VILLAGE OF MONROE
Regular Meeting Minutes
October 28 2025

Site Plan Review – Proposed 2 Story Office Building

Subject: Proposed Office Building, 573 Route 17M, Village of Monroe
Traffic Review

RE: Attorney comments on application regarding 110-114 Stage Road.

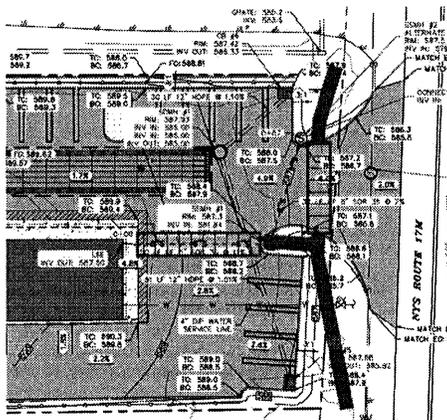
Comment 5: It is likely that NYSDOT will request the installation of a left-turn lane when an application is submitted for a permit to consolidate the 2 driveways.

Comment 6: A sidewalk is proposed along the property frontage. It would make sense if it could be connected to the sidewalk in front of the building. If grade (ADA access is an issue, it may be possible to accomplish ADA access by sliding the sidewalk in toward the driveway as shown below. The Applicant should provide justification for not doing so, if that is what they propose.
